Date: June 14, 2022

Re: Site Plan & Plat – Sienna @ Cooper City
Petition #SP 5-3-21 & #P 5-1-21

PETITION: Sienna – Final Site Plan and Plat

LSP.2
 OF 7 SHEETS

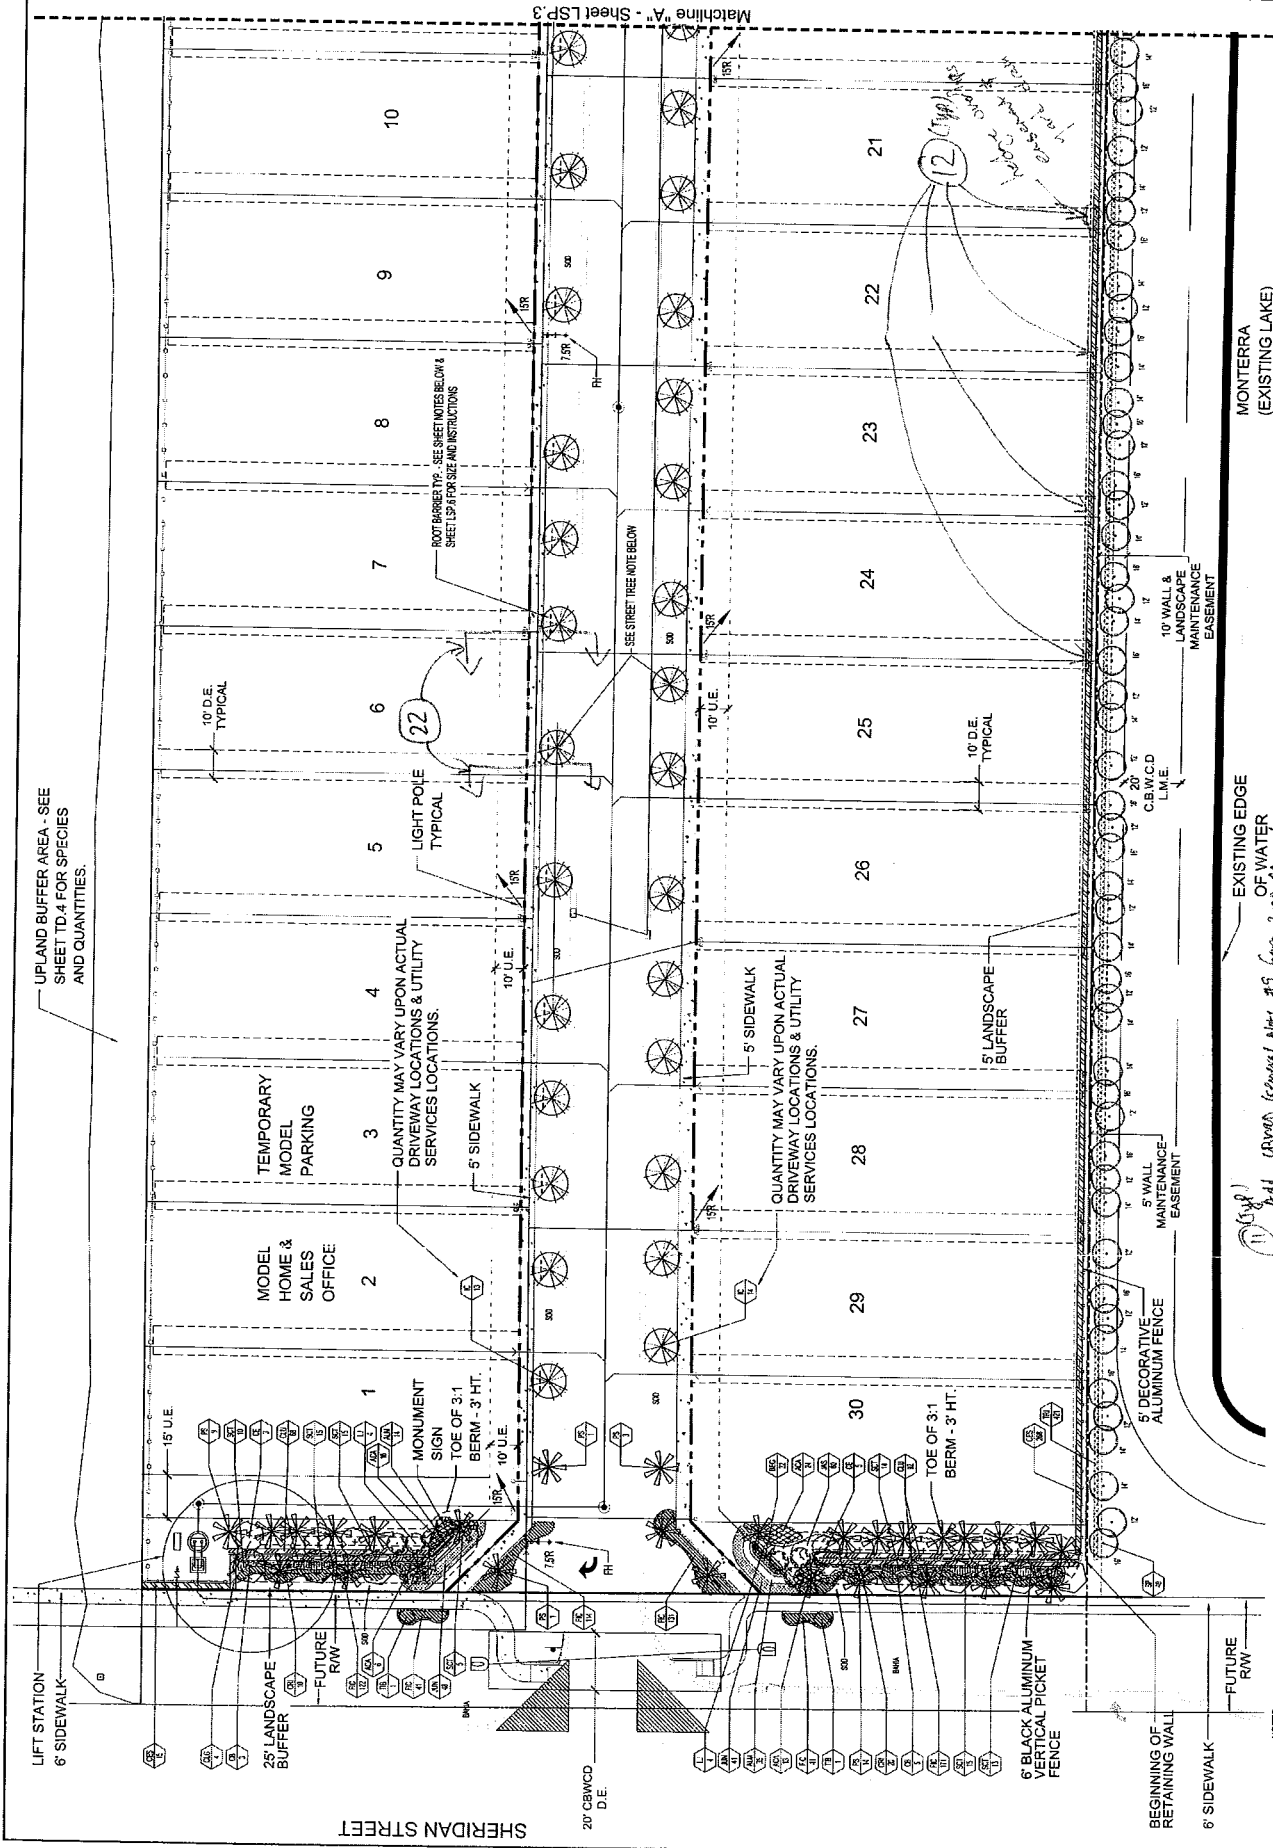
"It looks like the runoff will not be able to sheet flow from the inline drains to the stormwater trunk line at the locations shown on the Landscape Plans markup due to the presence of the tree root ball which will result in ponding. Please refer to Section A-A on the PGD plan set. Please rectify."

- 27. It looks like the runoff will not be able to sheet flow from the inline drains to the stormwater trunk line at the locations shown on the Landscape Plans markup due to the presence of the tree root ball which will result in ponding. Please refer to Section A-A on the PGD plan set. Please rectify.**
- 28. Please reconcile pad construction detail to be consistent with Section A on the PGD cross-sections sheet.**
- 29. Please depict wetland planting only in upland buffer on the Landscape Plans.**
- 30. Please rectify the "Road Tract and Utility Easement" label to state "Private Road and CBWCD Drainage Easement".**

In order to satisfy the comment, the proposed swale trees need to be located to an area away from the proposed storm drains which are all essentially located on each individual lot line within the proposed 10' CBWCD drainage easement. In keeping with this revision and also adhering to the previously mentioned setbacks, it was determined that one (1) swale tree per lot would be a good compromise as it would still provide a "street tree" theme for the community and adhere to all requirements.
